1400 GARDEN STREET GARDEN STREET ELEVATIONS

1400 GARDEN ST. **GARDEN ST. ELEVATIONS**

REVISED NAVASOTA ELEVATION - 08/03

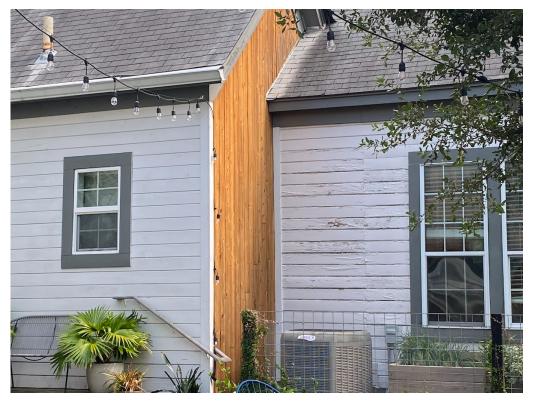
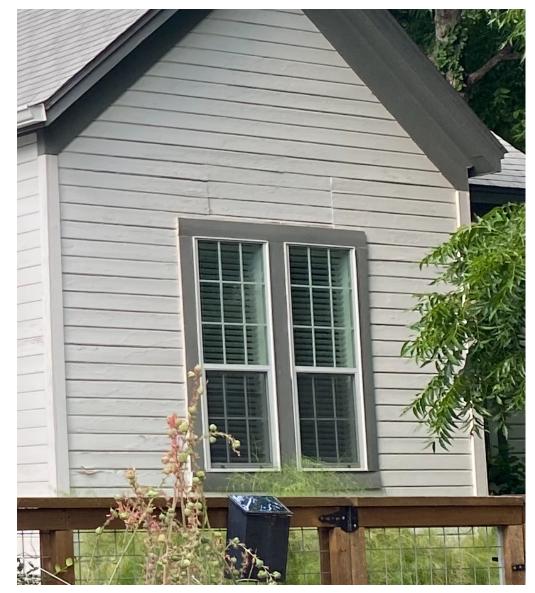
REVISED UPDATES TO ELEVATIONS:

- KEEP DOUBLE WINDOW PATTERN FOUND CURRENTLY ON HOUSE.

- SLIGHTLY LARGER WINDOWS THAN EXISTING - APPROPRIATELY SCALED FOR PERIOD CORRECT ARCHITECTURE. - REPLACE ROTTING SIDING WITH NEW WOOD SIDING TO MATCH EXISTING; PAINT TO MATCH EXISTING WHITE - REPAIR EXISTING PORCH AS NEEDED, DESIGN AND DIMENSIONS TO REMAIN.

- REPLACE AGING SHINGLE ROOF WITH MORE PERIOD CORRECT GALVANIZED METAL ROOF.
